Planning Commission Staff Report

Project Type: Amended Lighting Plan

Meeting Date: September 26, 2011

Description: Delmar Gardens: An Amended Lighting Plan for an 11.17 acre parcel of land zoned “NU” Non-Urban District with a Conditional Use Permit (CUP) located east of the intersection of Interstate 64/U.S. Highway 40-61 and Chesterfield Parkway East.

Delmar Gardens Chesterfield & Chesterfield Villas
Design Concept for approval
August 24, 2011

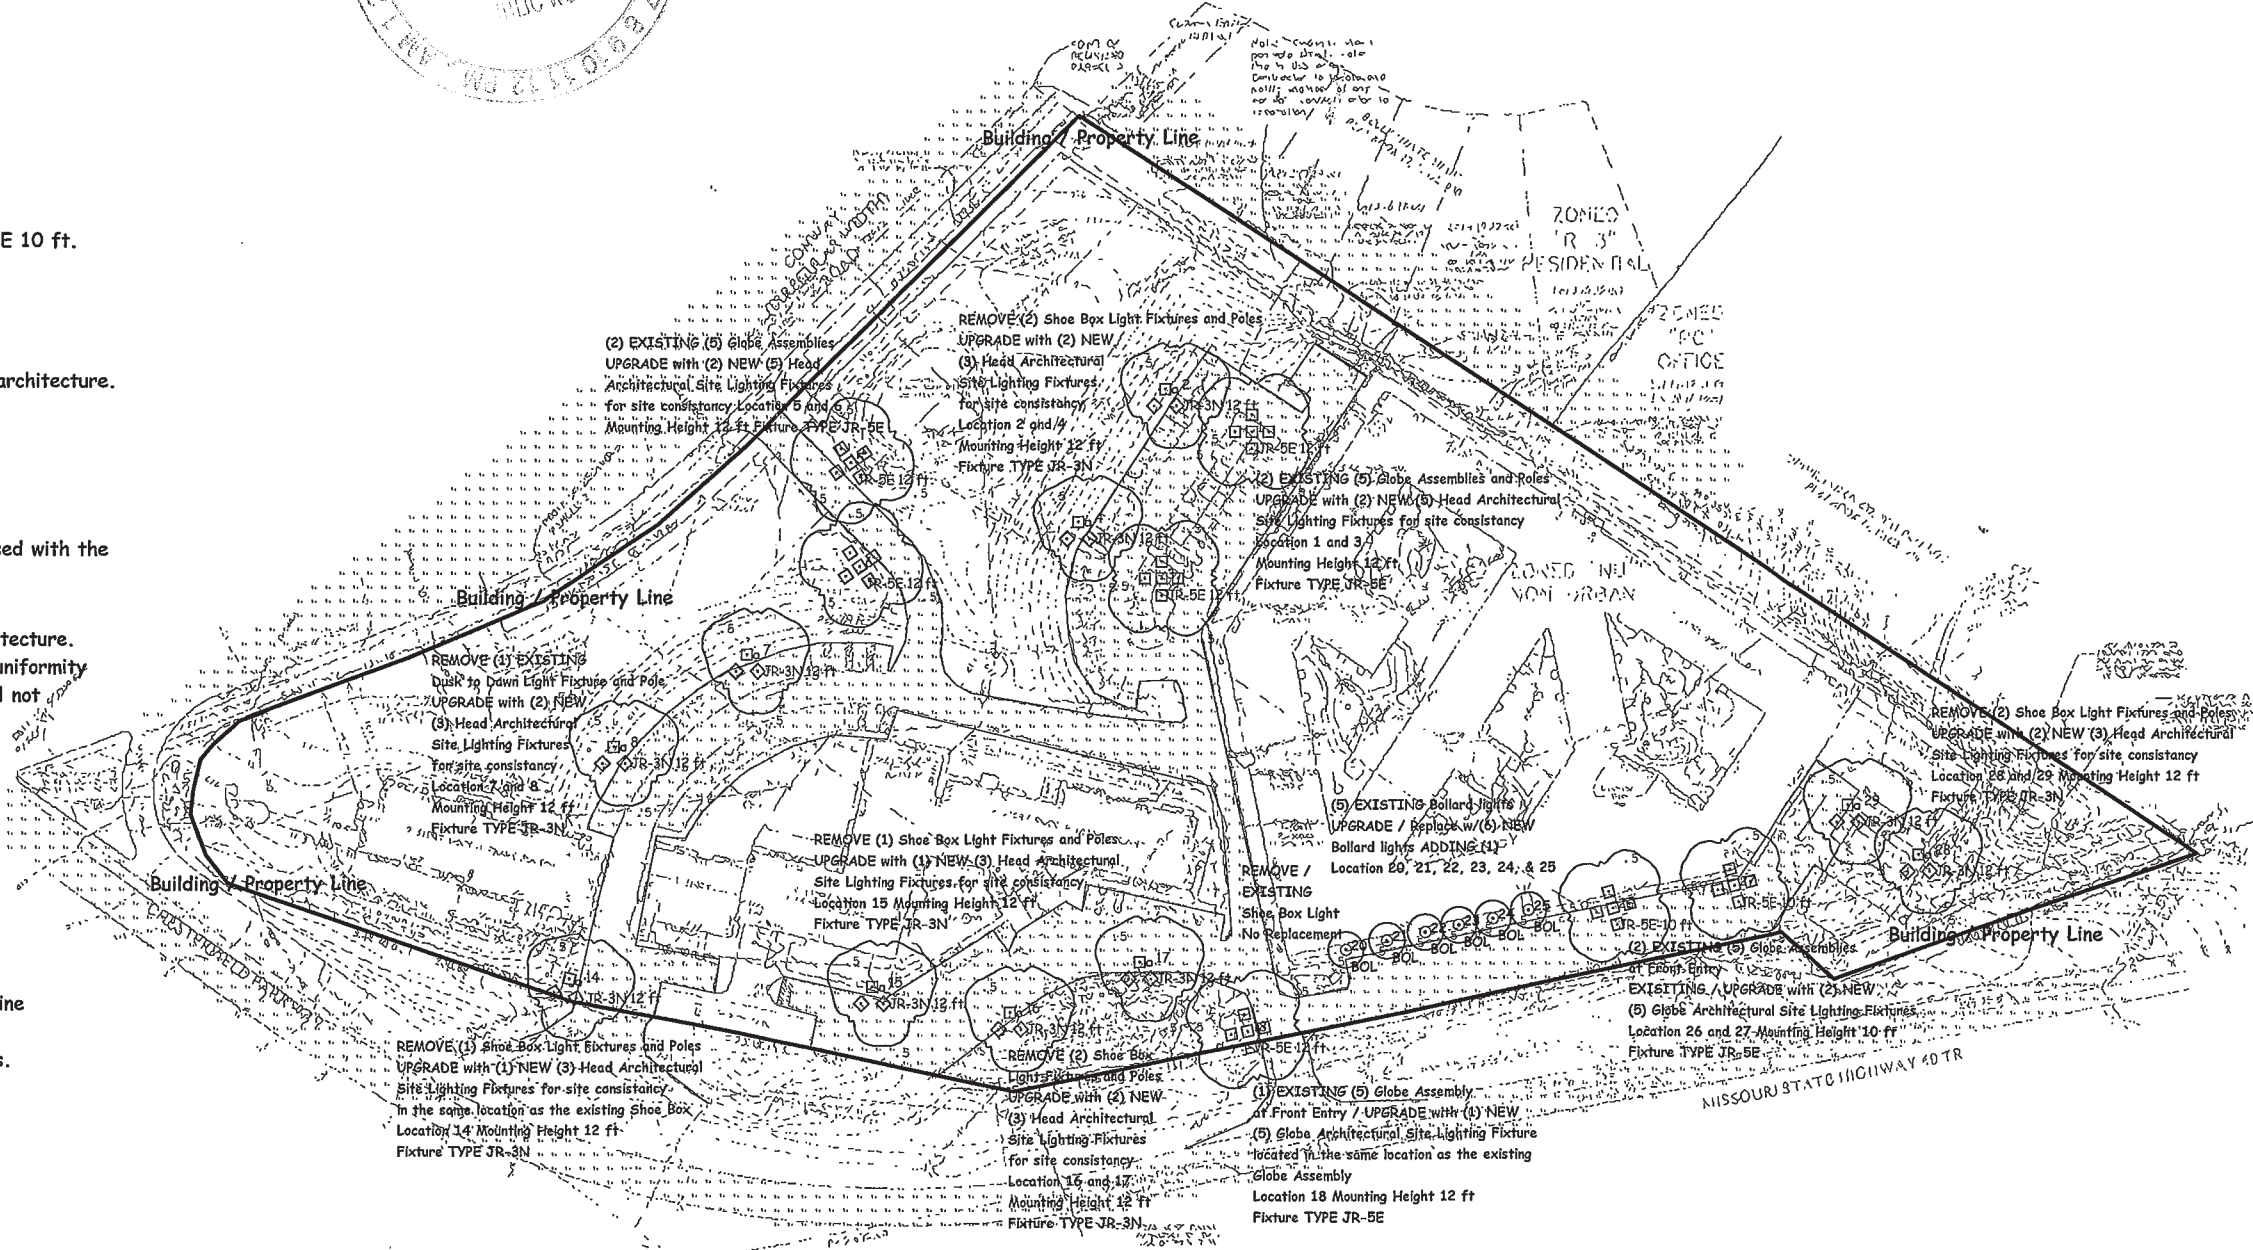
The existing lights on the site are a mixture of an older globe style fixture and a parking lot “shoe box” style fixture. The intent is to provide an overall consistency in the look and style of the fixtures and improve the appearance of the development. Sixteen of the seventeen light fixtures will be replaced in the same location. One fixture is being removed entirely from the site and one fixture is being added near a parking lot on the western edge of the site. Additionally, five existing bollard fixtures are being replaced by six new bollards which match the proposed decorative light fixture design.

Two light fixtures towards the front of the site have an off-site light level of above the 0.5 foot candle maximum. The location of these lights however was approved prior to the conveyance of right-of-way which changed the front property line of the development. Due to the extremely low level of the light trespass and the location approved prior to right-of-way conveyance, staff has no issues with approval of these fixtures.

The Amended Lighting Plan is before Planning Commission for review and approval due to the use of decorative light fixtures under fixture design exemptions of the Lighting Ordinance. Staff has reviewed the Amended Lighting Plan and has found the proposal to be in conformance with Conditional Use Permit #391 and all other applicable Zoning Ordinance requirements. Staff recommends approval of the Amended Lighting Plan for Delmar Gardens.
